Project Name: 126 SE 7th Avenue
Project Location: 126 SE 7th Avenue, Marina Historic District
Request: Certificate of Appropriateness and Variance
Board: Historic Preservation Board
Meeting Date: June 13, 2018

STAFF REPORT

ITEM: 126 SE 7th Avenue, Marina Historic District – Certificate of Appropriateness (2017-274) for two (2) 65 sq. ft. exterior additions, renovations, two new pools, landscaping, hardscaping and Variance (2018-011) to reduce the side interior setback from the required 15' to 7.5'.

A6 NEW SOUTH EXTERIOR ELEVATION

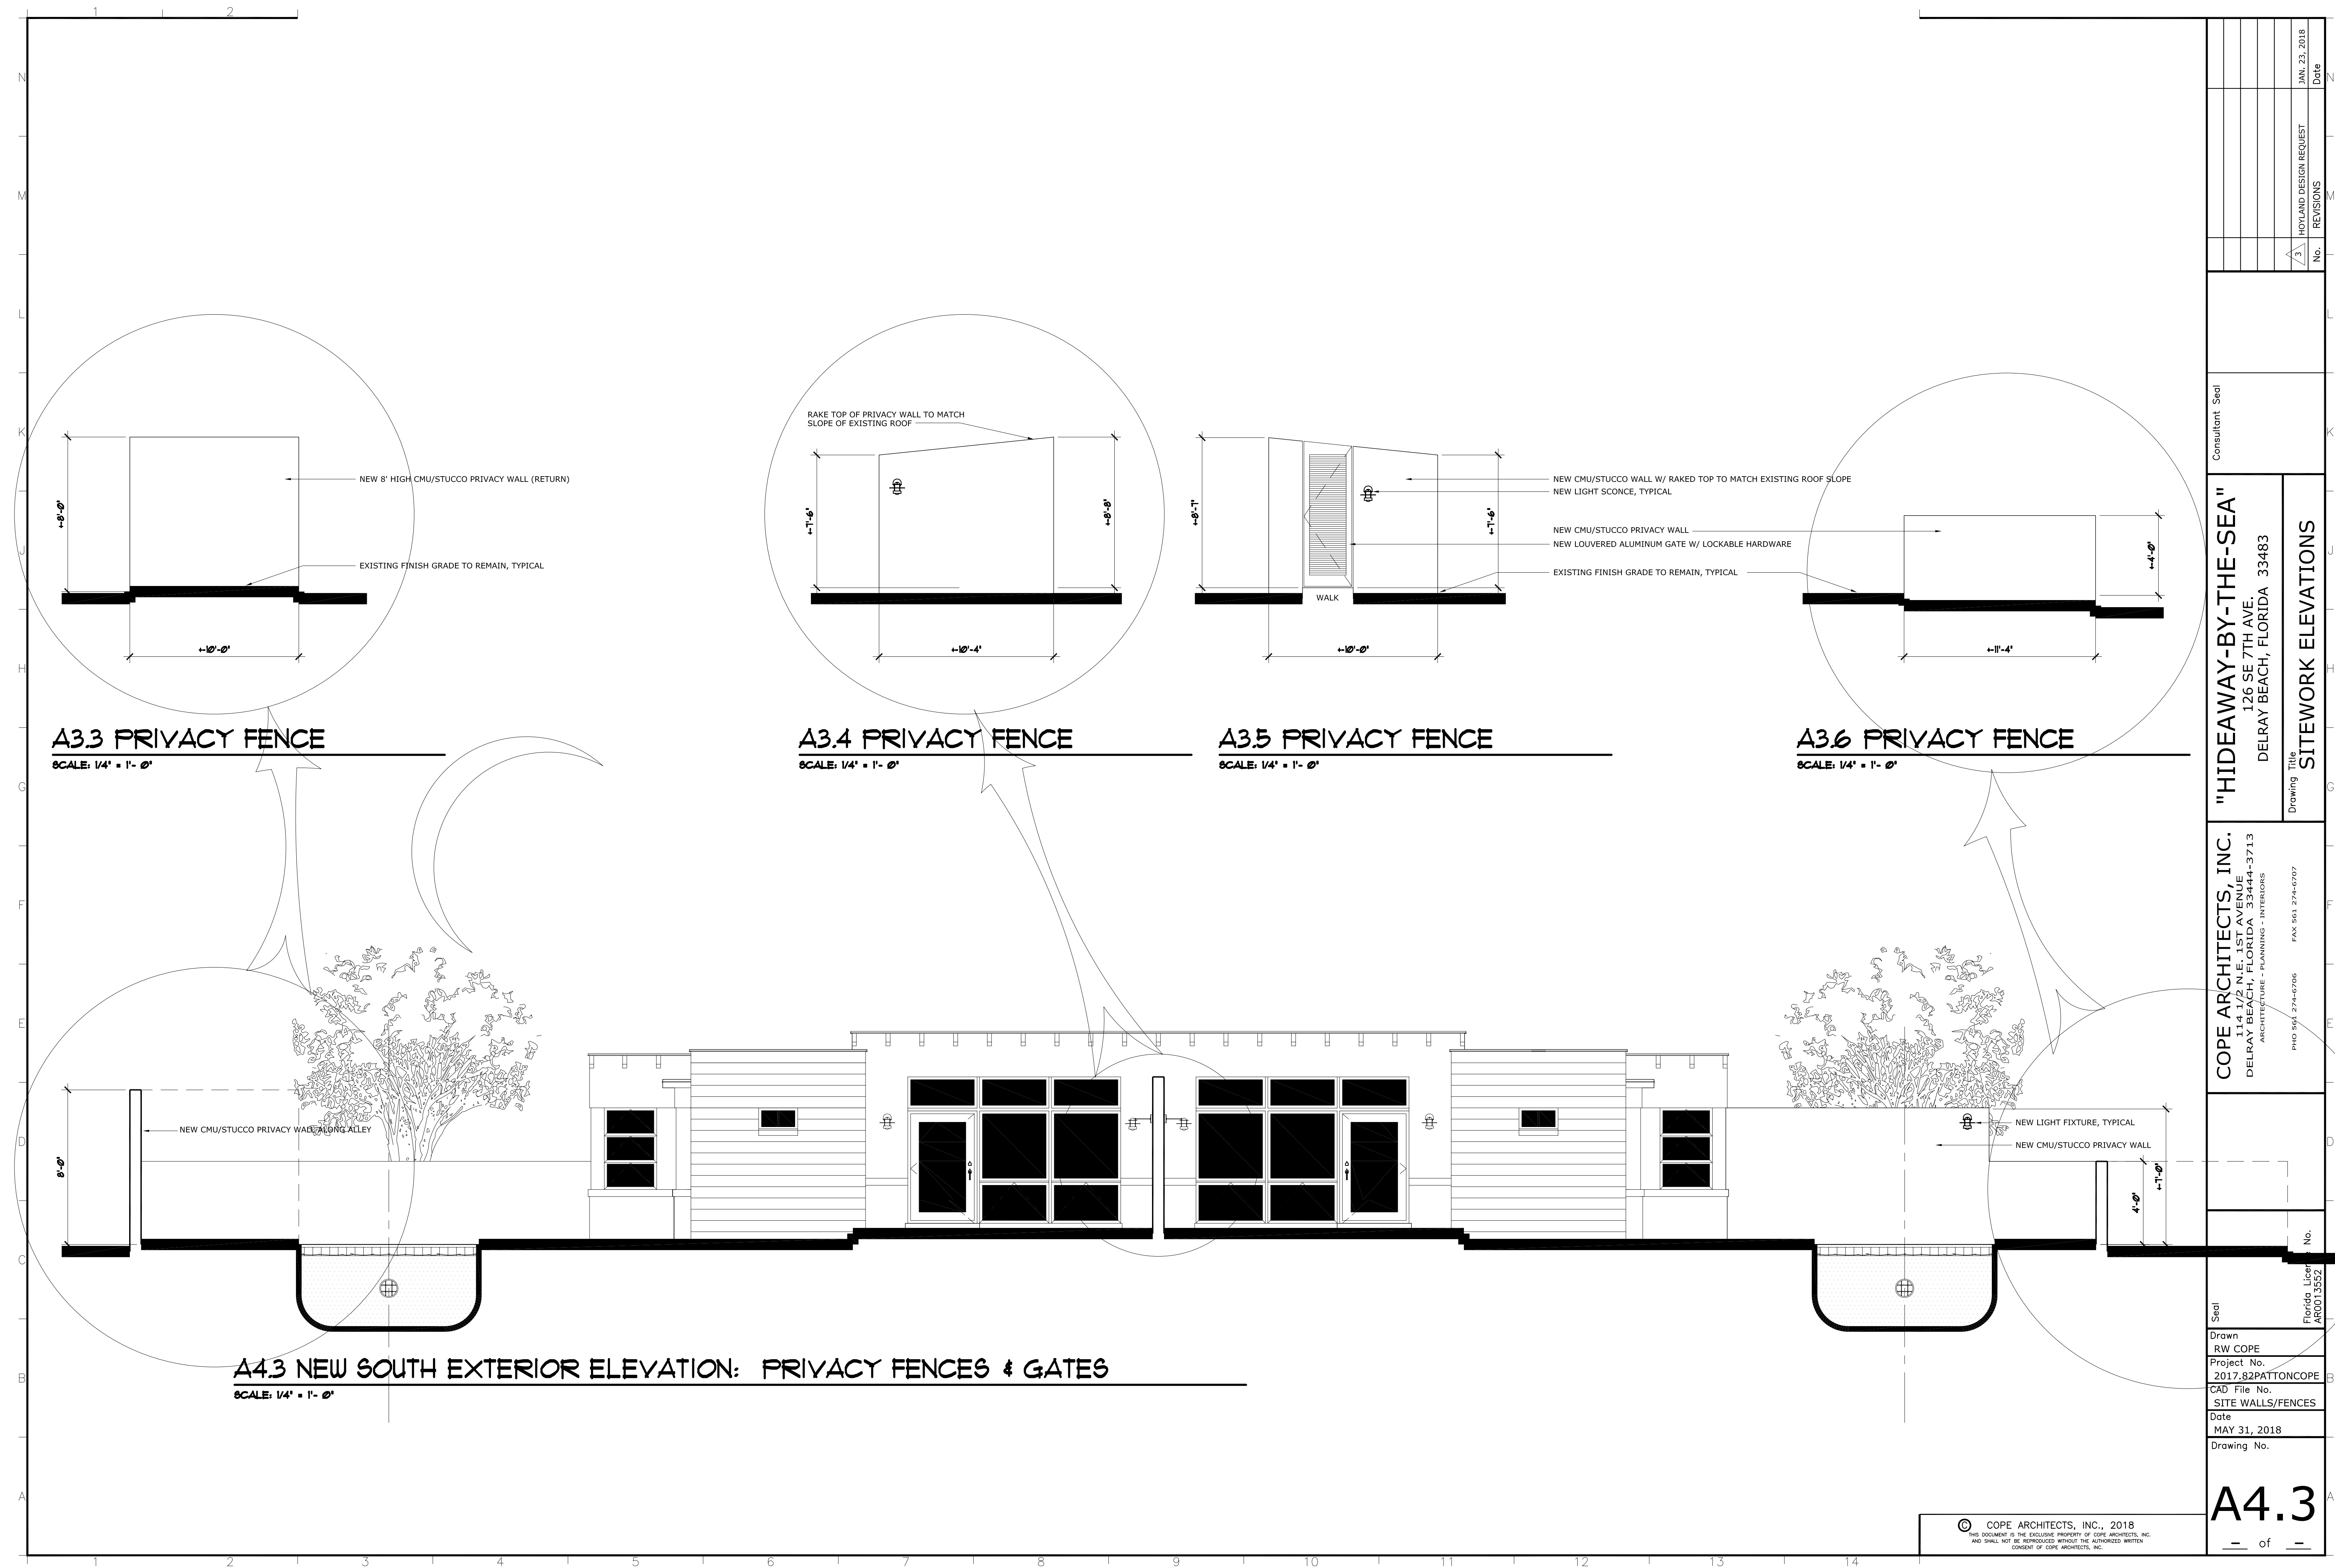
1. That the survey's legal description be revised to match the legal description on the property's warranty deed.
2. That the windows on East and South Elevation be reconfigured to "sit" on the existing concrete sill.
3. That the new 8'-8" high sloped concrete block/stucco privacy wall which is attached to the structure be revised to not exceed 8'-0" in height.

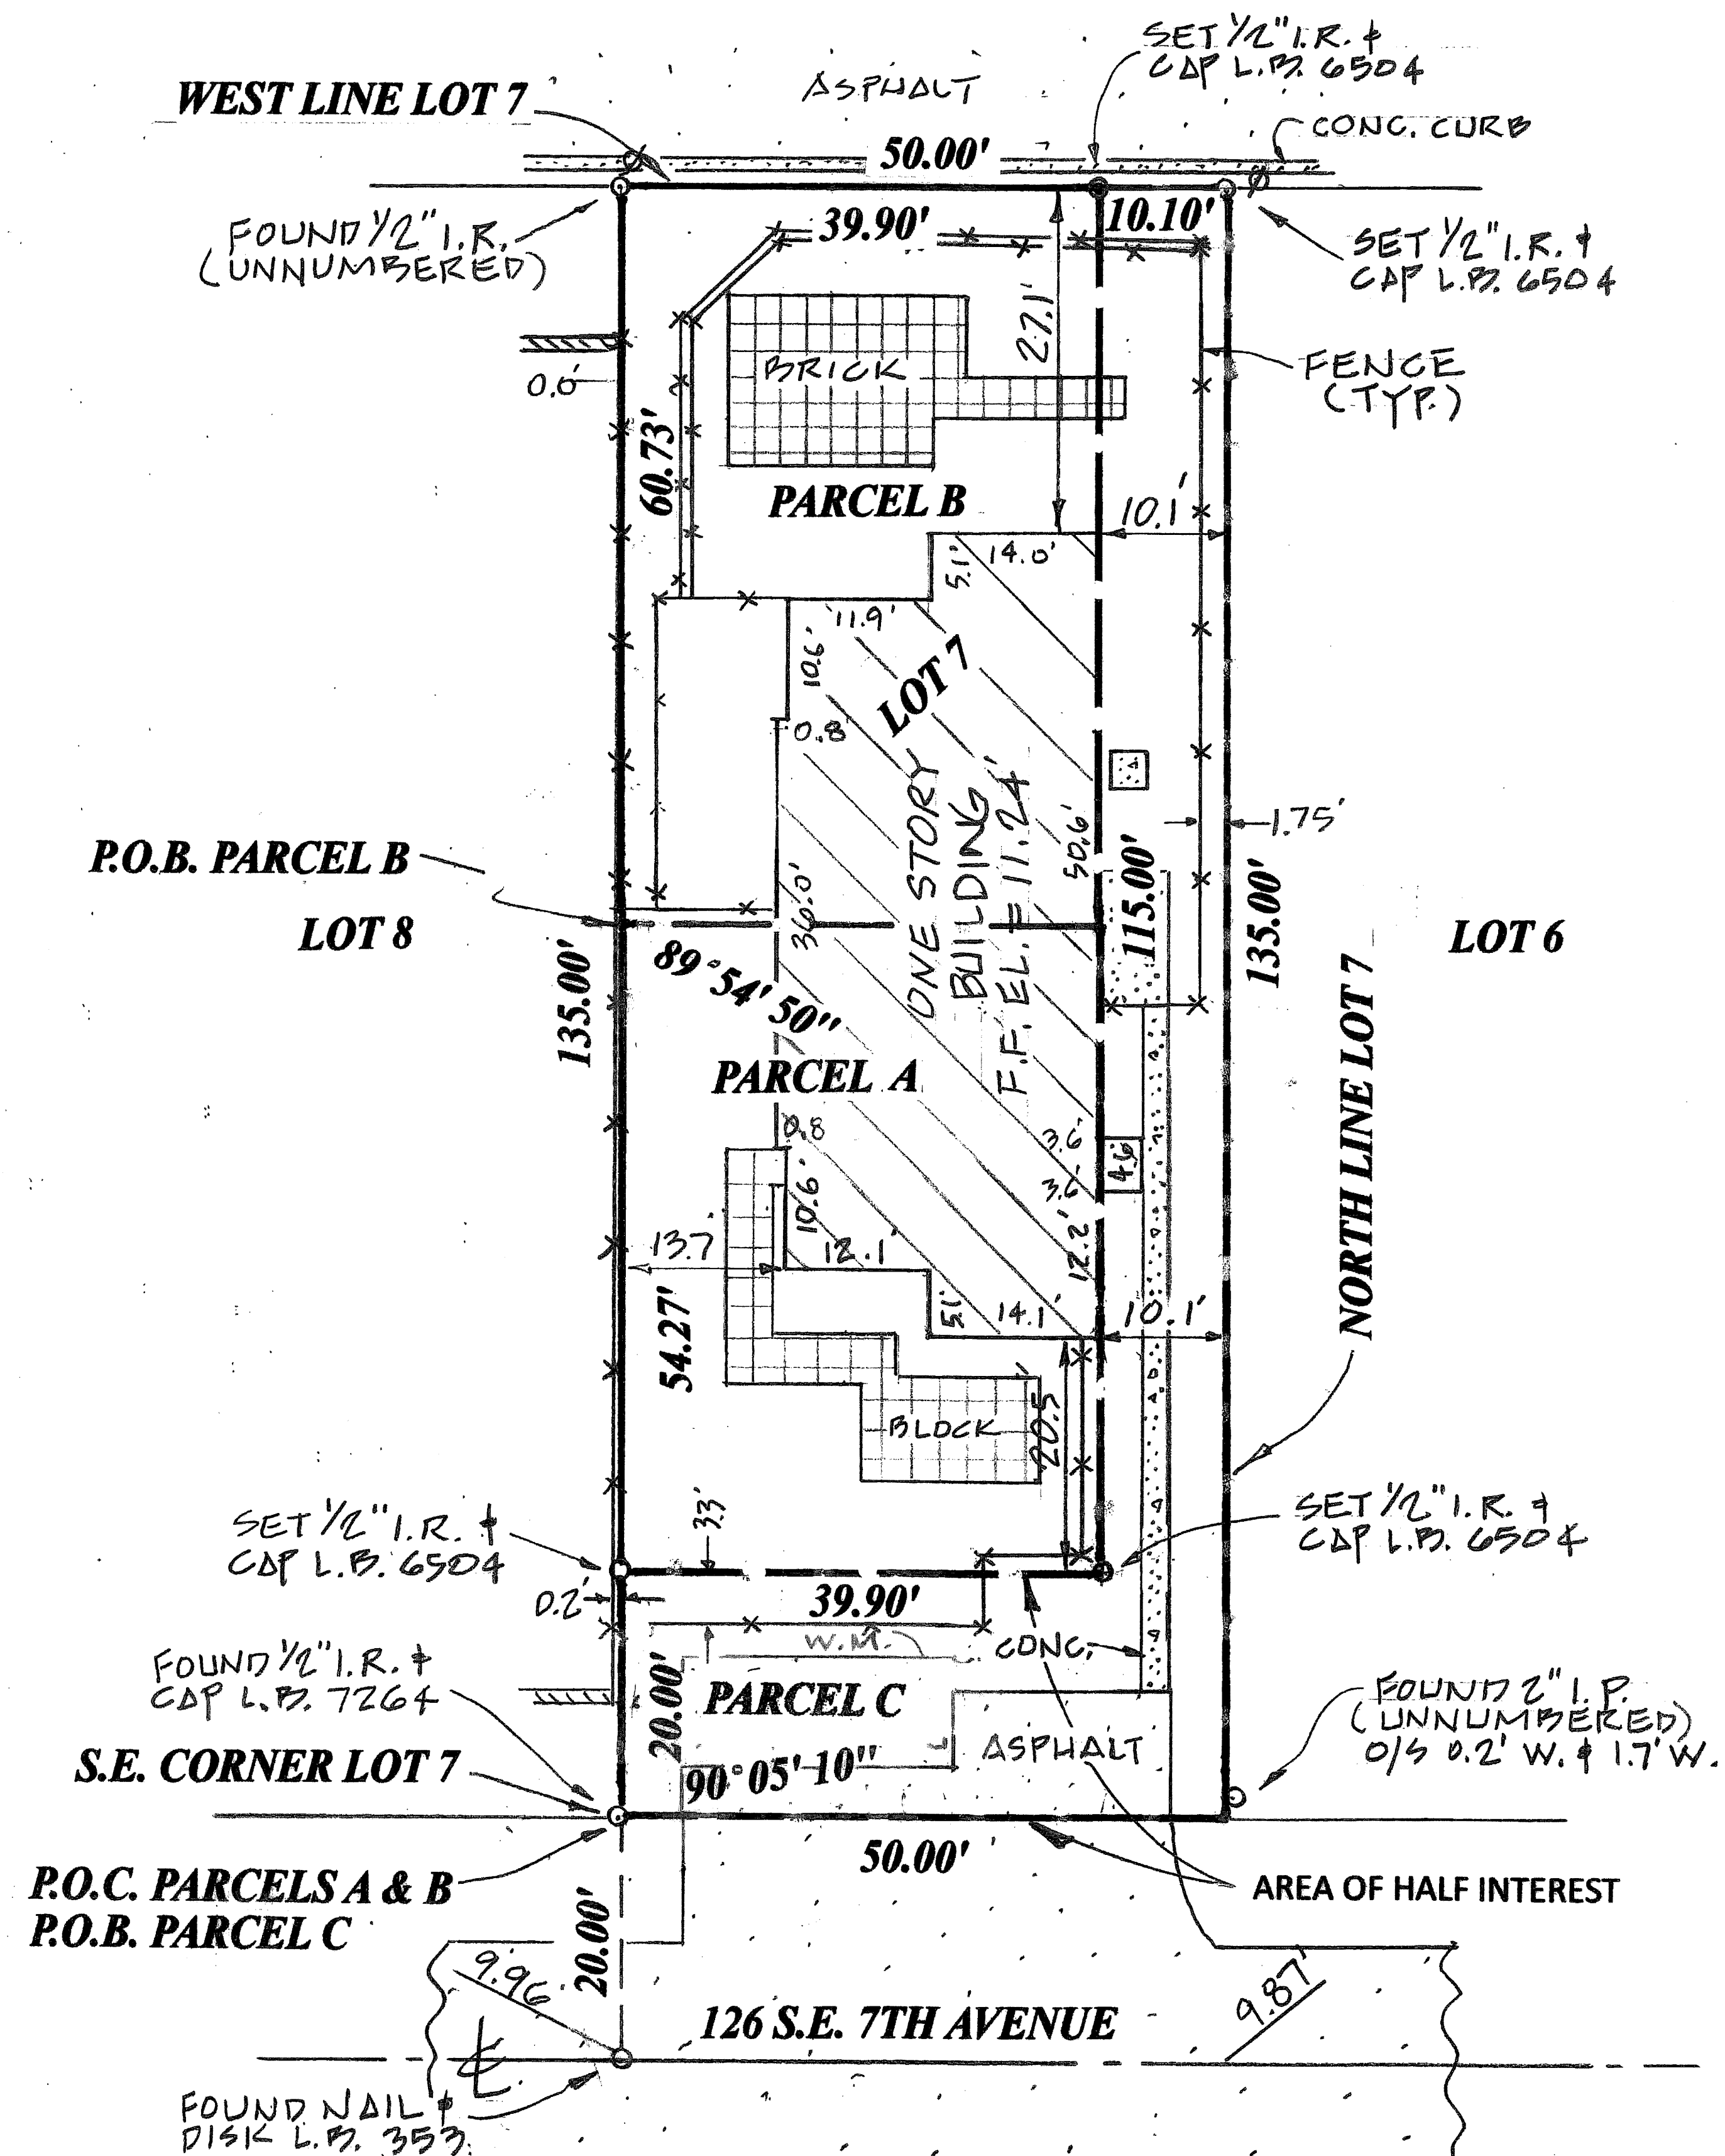
1. That the survey's legal description be revised to match the legal description on the property's warranty deed.
2. That the new 8'-8" high sloped concrete block/stucco privacy wall which is attached to the structure be revised to not exceed 8'-0" in height.
